July 24, 2000

SUBJECT: DETERMINATION ON THE SUITABILITY OF PROPOSED FEDERAL AND NON-FEDERAL OPERATION AND MAINTENANCE DREDGED MATERIAL FROM SQUALICUM WATERWAY, BELLINGHAM BAY, PUGET SOUND (Public Notice CENWS-0D-TS-NS-9) EVALUATED UNDER SECTION 404 OF THE CLEAN WATER ACT (CWA) FOR OPEN-WATER DISPOSAL AT THE BELLINGHAM BAY NON-DISPERSIVE DISPOSAL SITE, ROSARIO STRAIT DISPERSIVE DISPOSAL SITE, OR AT A BENEFICIAL USE SITE.

Figure 1. Ni concentrations vs. percent fines.

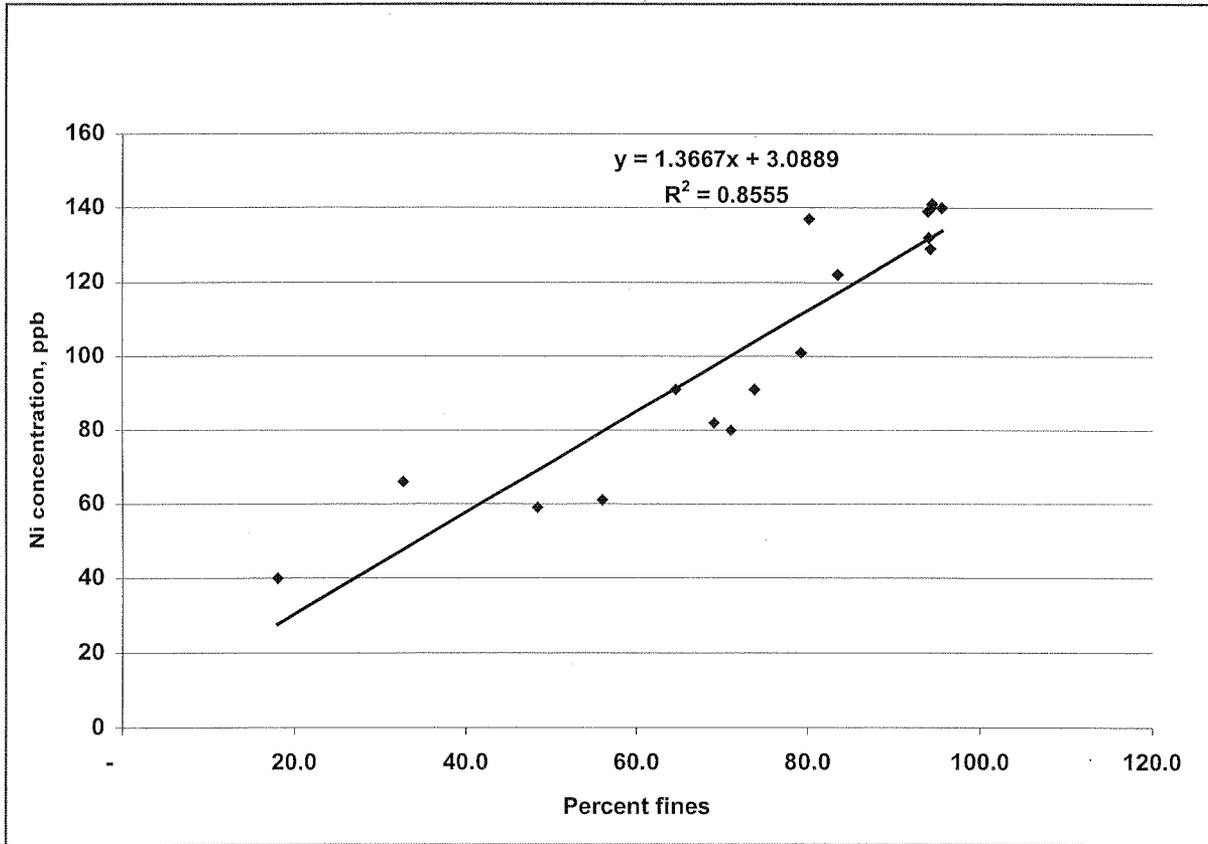
6. Nickel Exceedances. Three DMMU (C5, C6 and C7) in the turning basin area of the navigation channel had nickel detected right at the SL. Analysis of the data showed that Ni concentrations were localized in the surface portion of the turning basin material, and decreasing concentrations with increasing distance from the turning basin. Grain size showed a high negative correlation with Ni concentration (Figure 1). Similar concentrations have been found in the waterway in past sampling. Though SL exceedances usually trigger Tier 3 bioassays before being found suitable for open water disposal, the agencies' suspended this requirement for these DMMU. This "best professional judgement" decision was based on the following lines of evidence:

- similar and greater levels of Ni found in the same area before have passed bioassays
- there is circumstantial evidence that background levels of Ni in the Bellingham Bay area are high
- there are no apparent anthropogenic sources
- these DMMU showed no SL exceedances of any other COC

FIGURE: 2
Actual DMMUs and Sampling Locations at the Head of Squalicum Creek Waterway

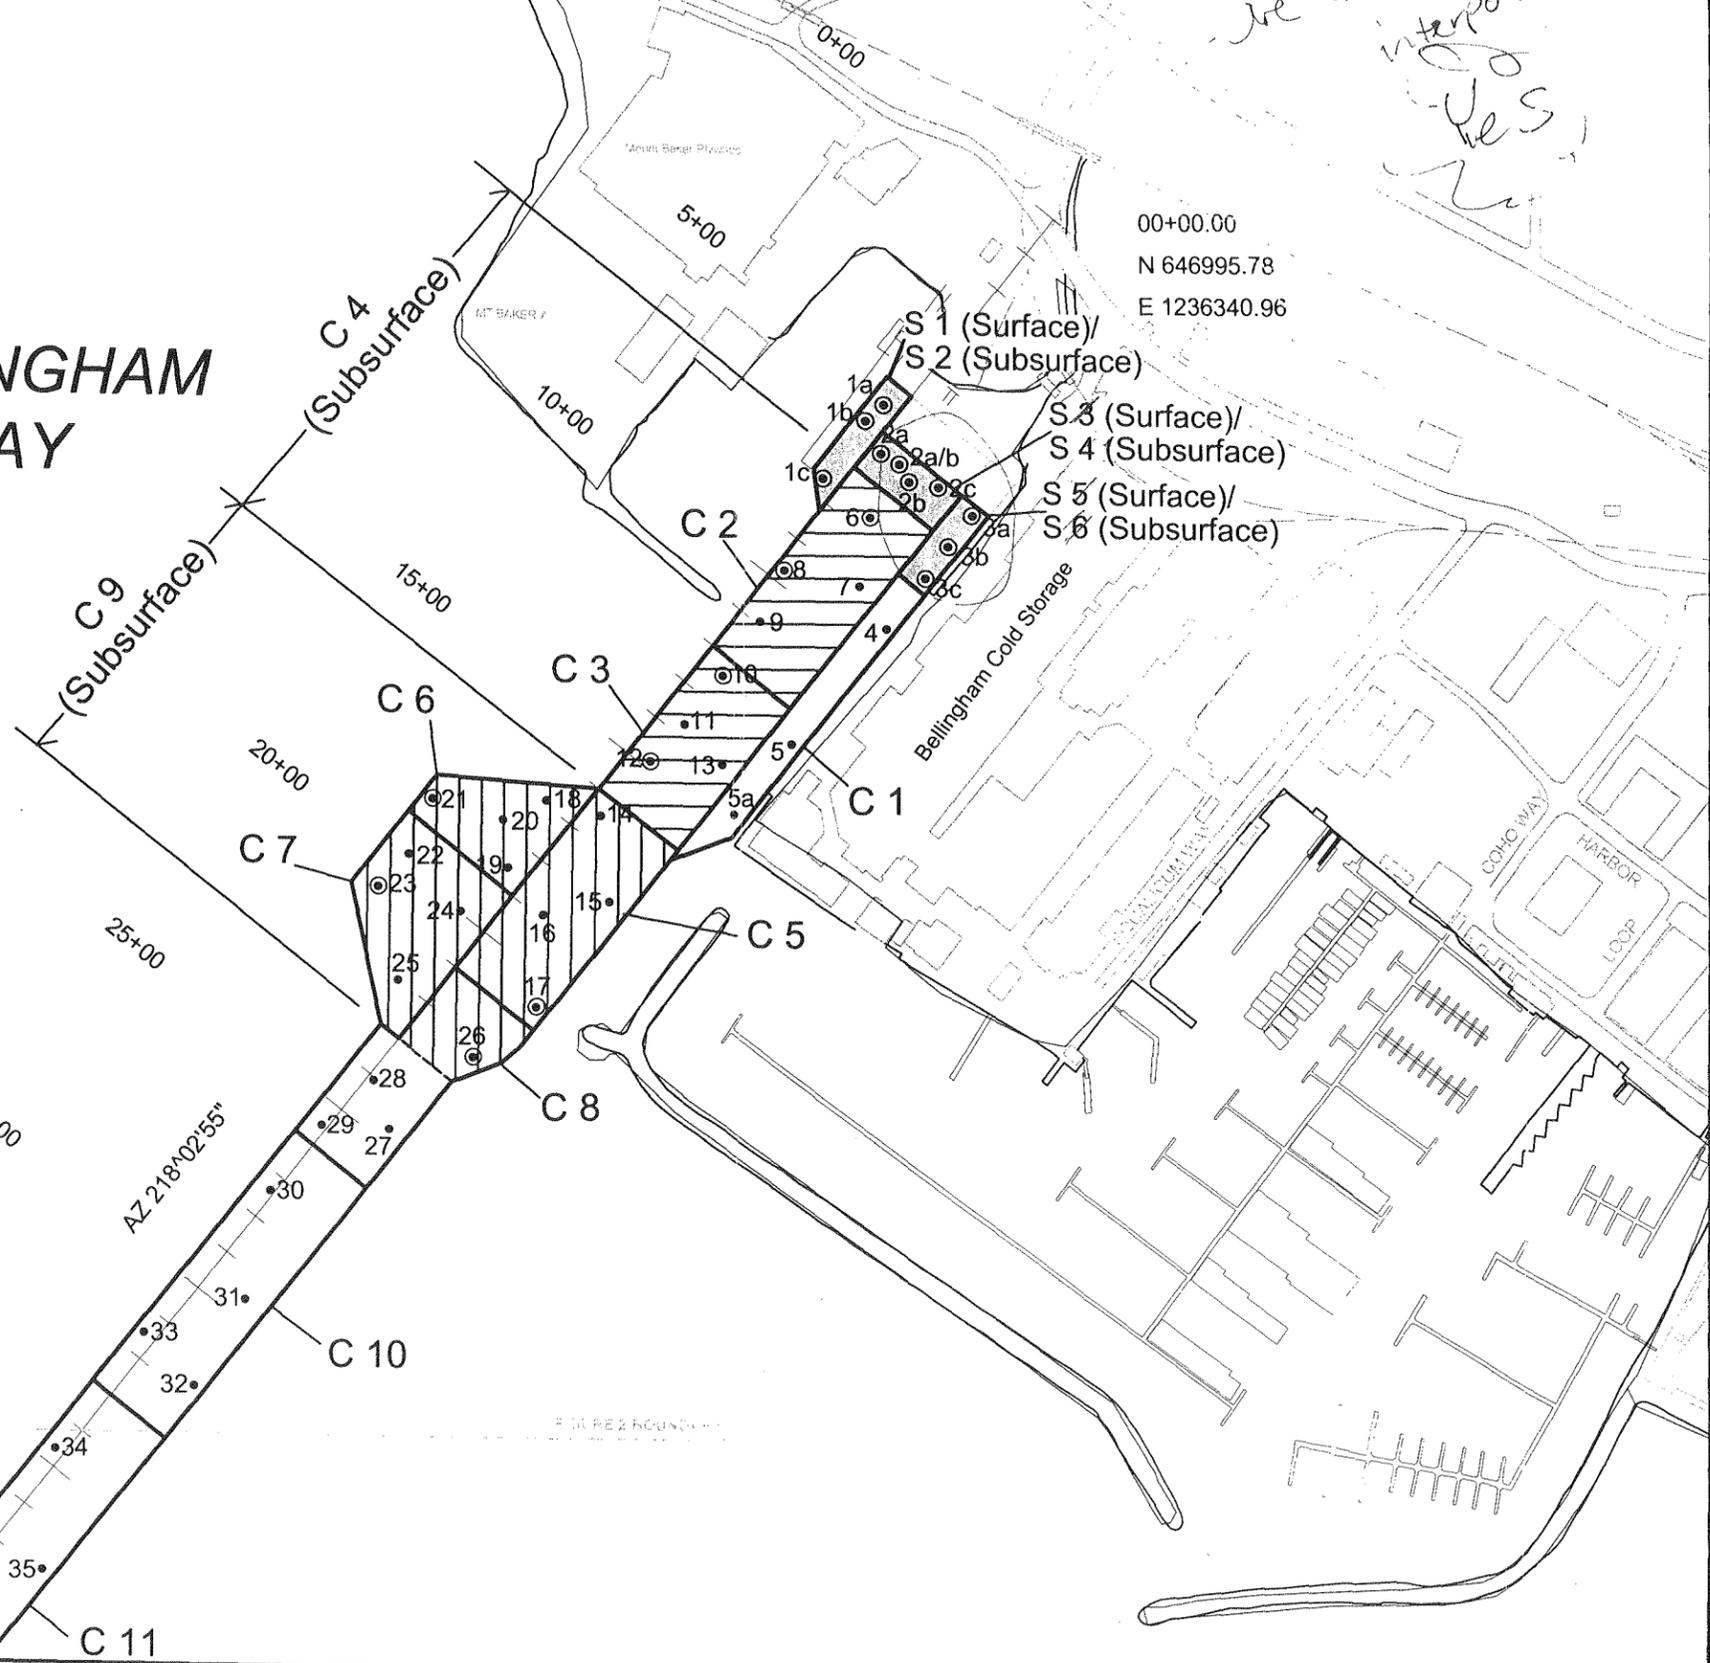
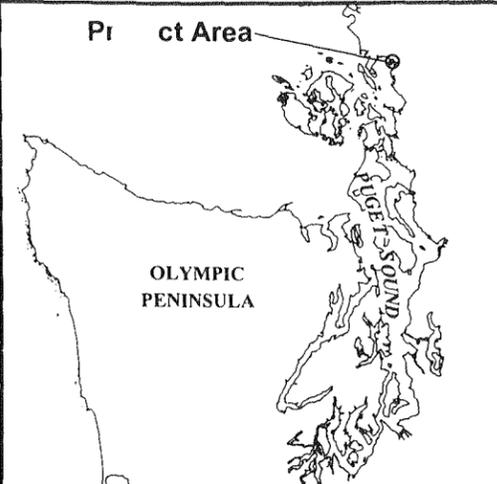
7. S2: Lead and 2,4-dimethylphenol Exceedances. Subsurface DMMU S2, in the right berth area, had both an SL exceedance of 2,4-dimethylphenol and an ML exceedance of lead (Table 5). This level of lead caused much more concern among the agency representatives than did the detections of nickel. To establish an approach for further testing of this DMMU, the agencies looked at the site history, laboratory QA/QC data, and potential human health and environmental effects of lead.

A review of the site history showed that both a plywood company and a boat building business have been located in the area north of the right berthing area since the 1920s. Boat building, of both metal and wooden boats, ceased in the 1960's, though a plywood company continues to operate today. This area was filled to its present shoreline in the 1940s and 50s. At present, the source or extent of subsurface contamination is undetermined.

With the above information, the agencies agreed on a plan for further evaluation of S2. The following Tier 3 tests were required before S2 could be considered for open water disposal:

- Acute bioassays with the usual suite of bioassay tests. *Mytilus* should be the species chosen for the larval bioassay due to its sensitivity to metals. Should the sediment fail these tests, it would be unsuitable for open-water disposal.

- 28-day bioaccumulation tests on two species before the sediment could be considered suitable for open-water disposal. Tissue analysis would be for Pb only.

- Should the area be dredged, regardless of disposal area, Z samples would need to be analyzed to make sure that the exposed surface does not exceed Ecology non-degradation standards. Further dredging may be necessary if contamination is shown to go deeper than the proposed dredging prism.

- Bioassay and bioaccumulation tests could be tiered or conducted concurrently.
- Though it was found suitable for open-water disposal, no portion of S1 should be removed without further testing of subsurface sediments.
